Project Name: Council Rock School District
Newtown Elementary School Chiller Replacement
DEI Project No. 283091

*This Addendum forms a part of the Contract Documents and modifies the original Bidding Documents dated **February 2024**. This addendum must be acknowledged on the Bid Form in the space provided for this purpose. Failure to so acknowledge this addendum may subject the Bidder to disqualification.*

1.1 This addendum consists of 5 pages including the following attachments:

Sheet Title:
 PARTIAL MECH ROOM /
 CHILLER PLAN -
 DEMOLITION AND NEW
 WORK

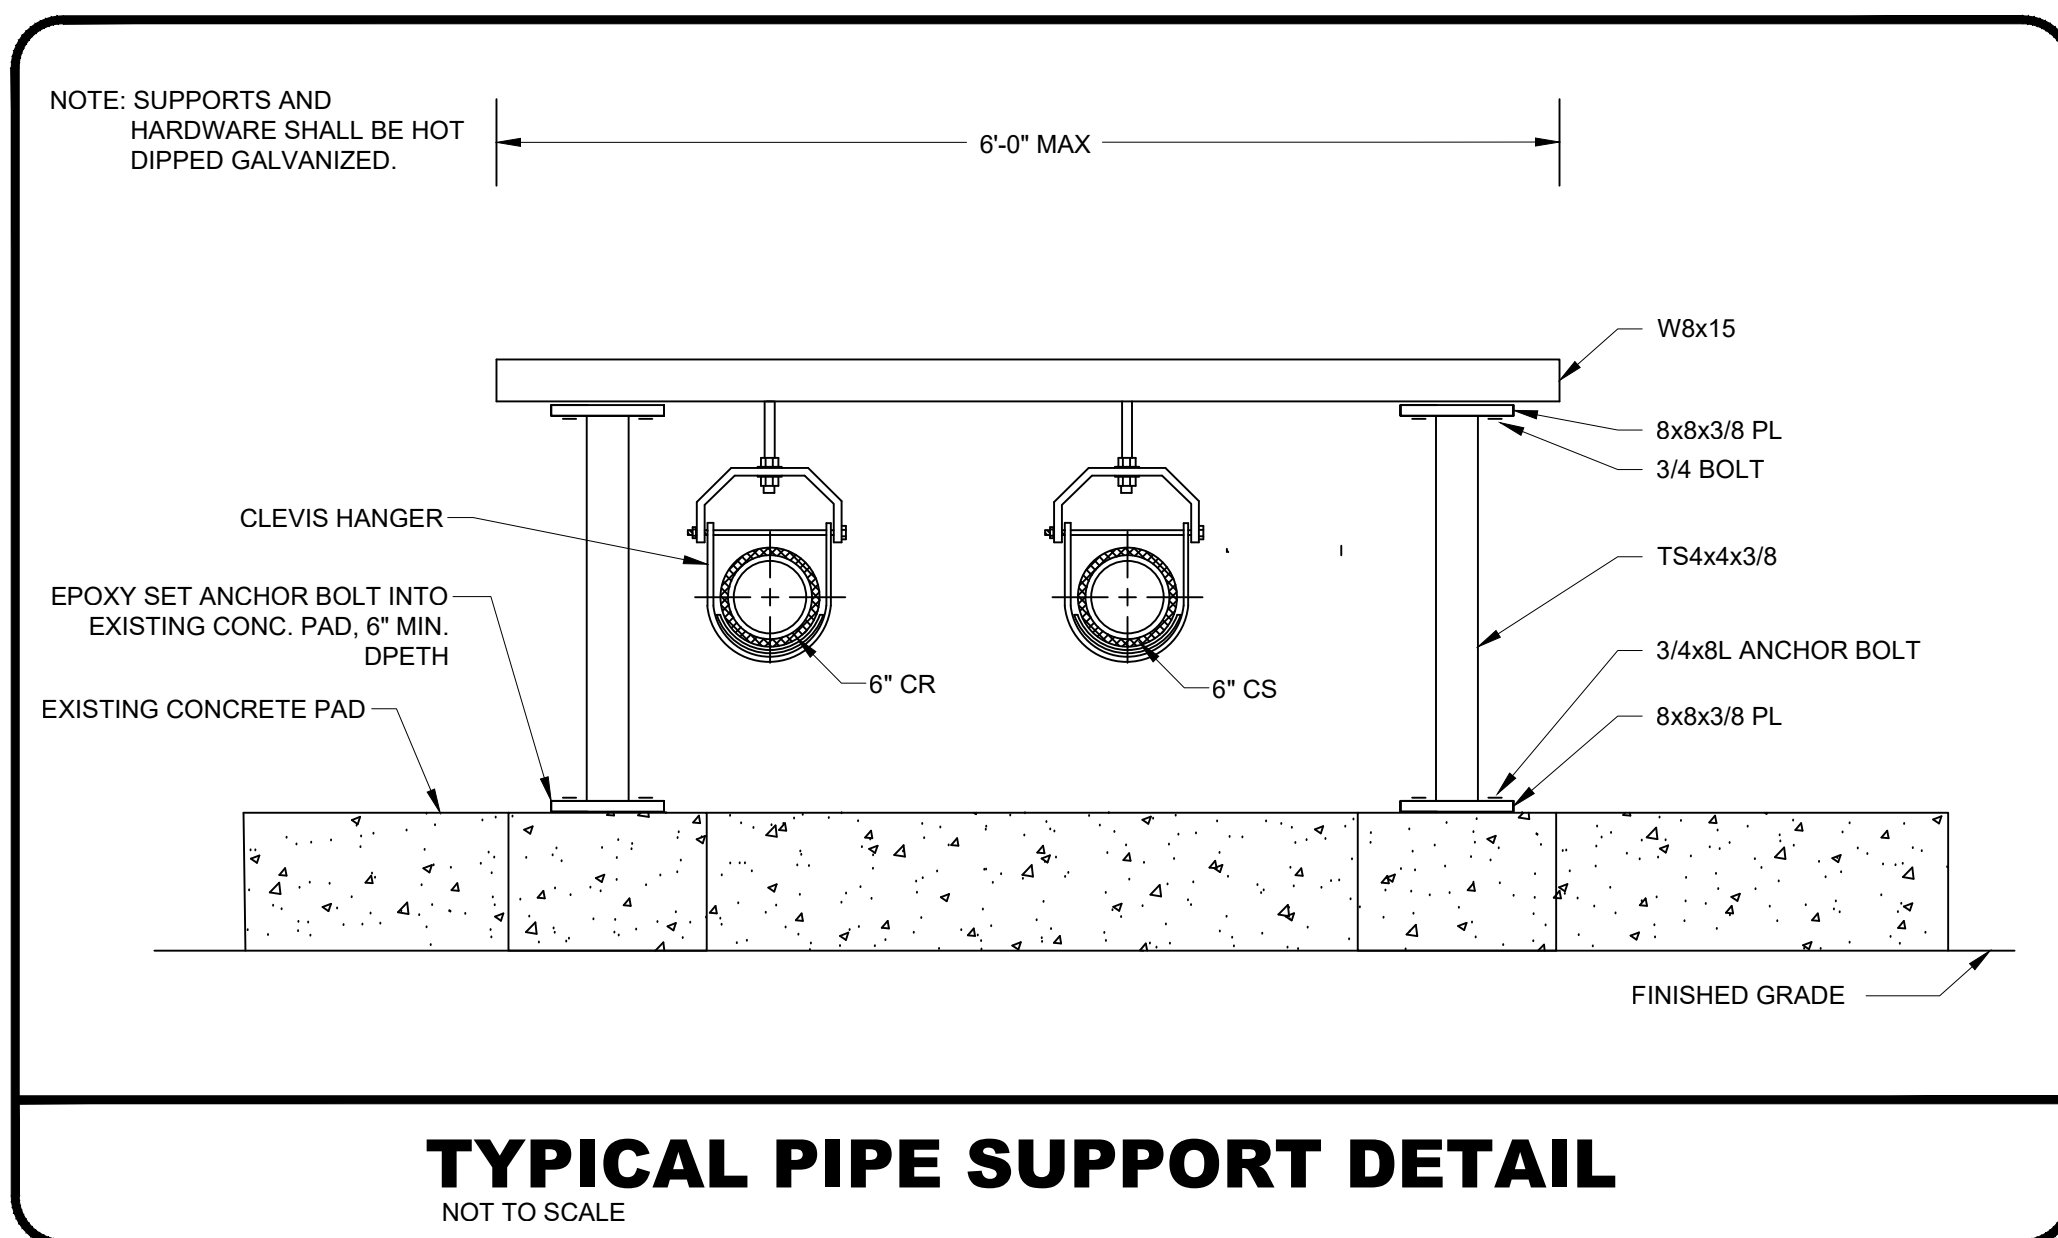
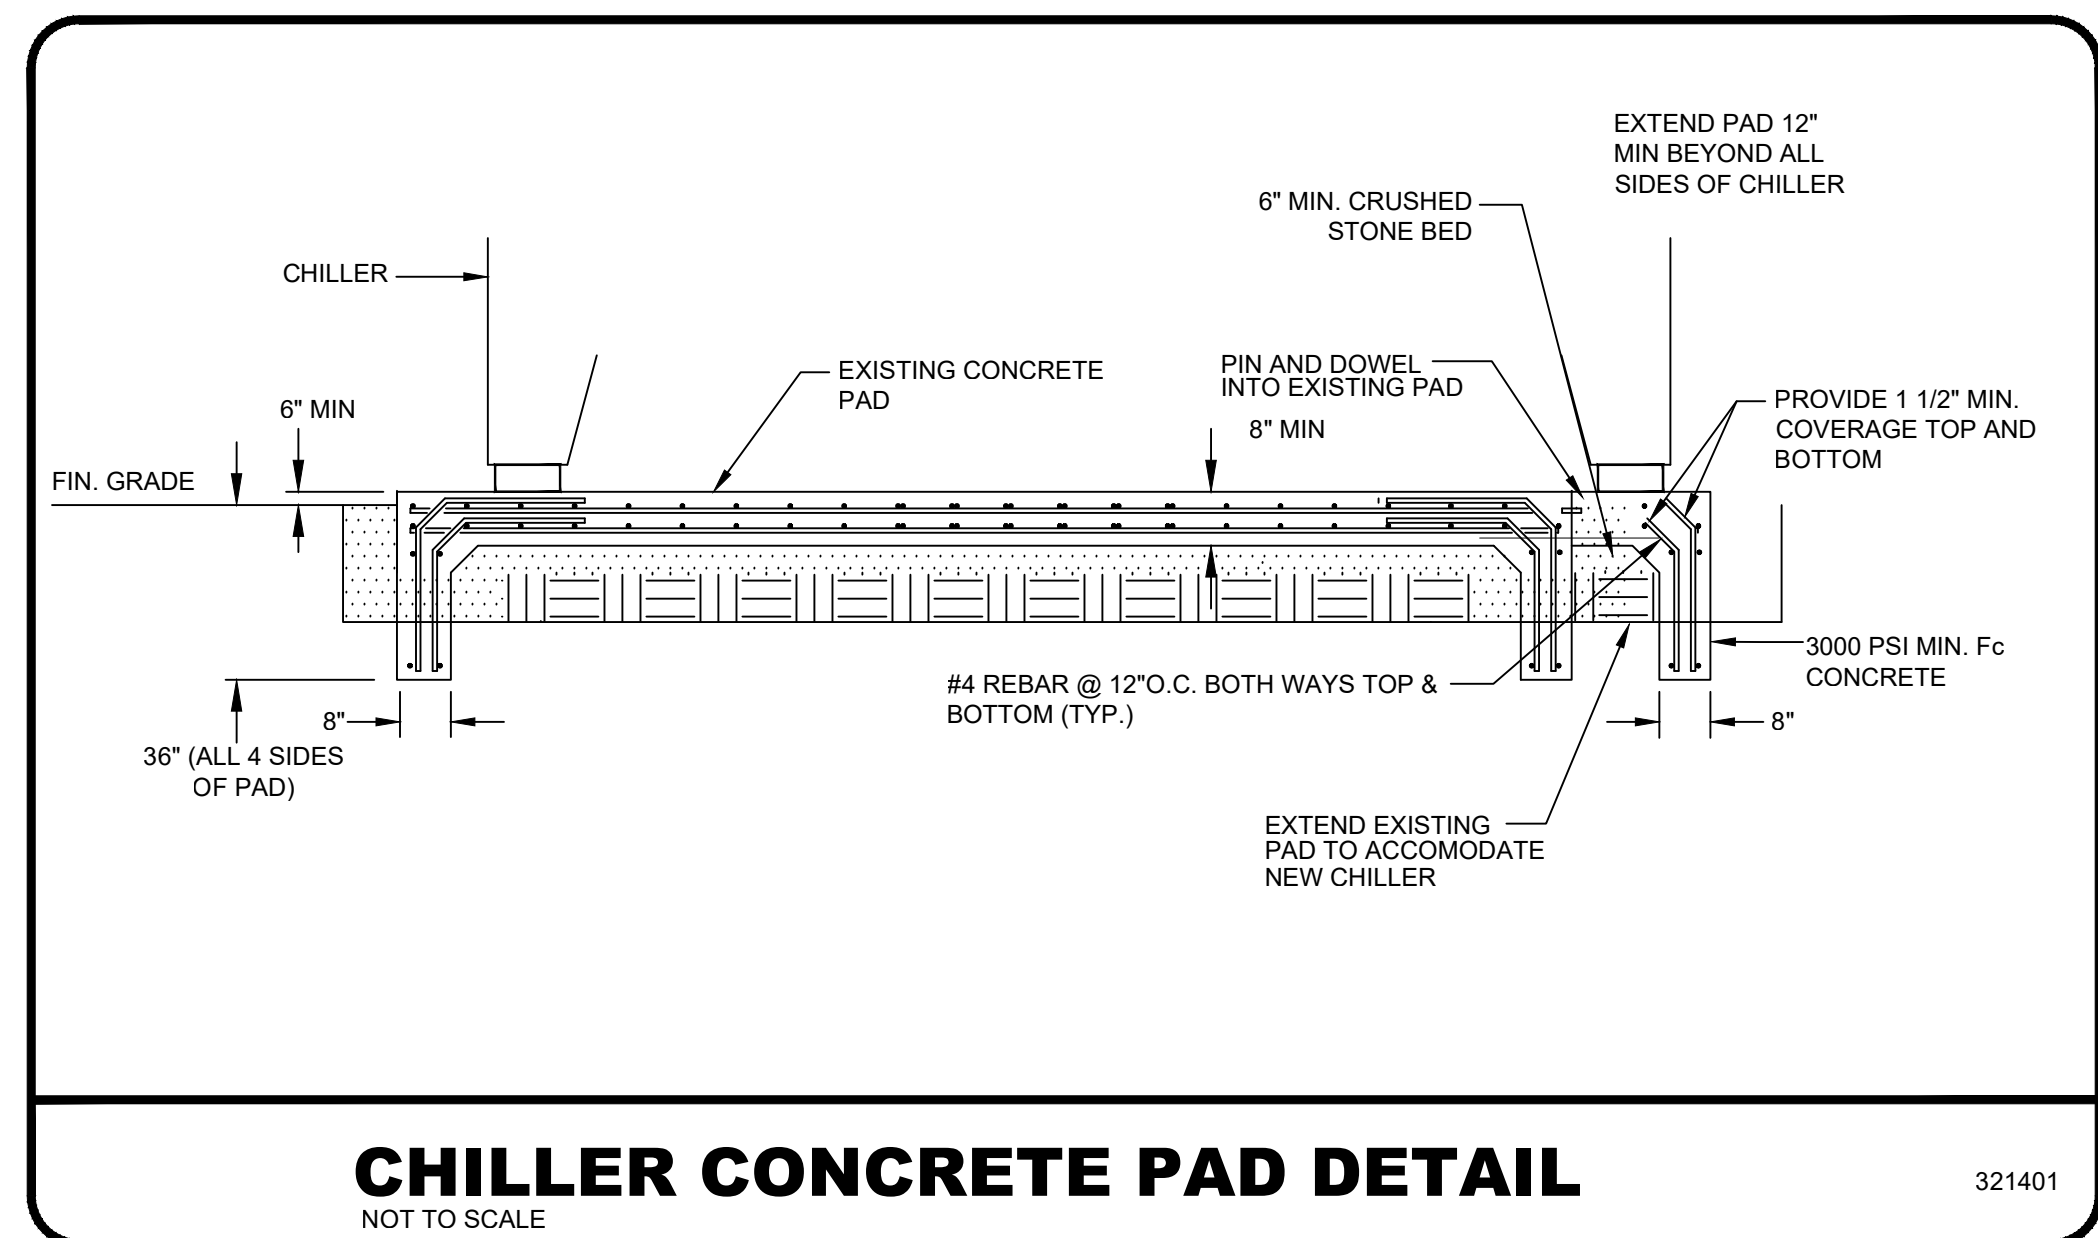
5.1 Drawing H2.1 “Partial Mech Room / Chiller Plan - Demolition and New Work” **REVISE** the current drawing as follows:

- a. Replace existing pump motor starters with variable frequency drives for existing chilled water pumps P-6 and P-7.
- b. Revise Key Note #6 pertaining to existing glycol feeder drain valve.

- 6. INSTALL DRAIN VALVE IN ASSOCIATED EXISTING GLYCOL FEED PUMP SYSTEM. PROVIDE DRAIN VALVE w/THREADED HOSE CONNECTION AND CAP
 - 7. INSTALL NEW PIPE SUPPORT.

- 8. PROVIDE VFD-P6, RECONNECT TO EXISTING ATC SYSTEM.
 - 9. PROVIDE VFD-P7, RECONNECT TO EXISTING ATC SYSTEM.
 - 10. EXISTING PRESSURE RELIEF VALVE TO REMAIN. COORDINATE P-6, P-7 MINIMUM SPEED SETTINGS w/ENGINEER.
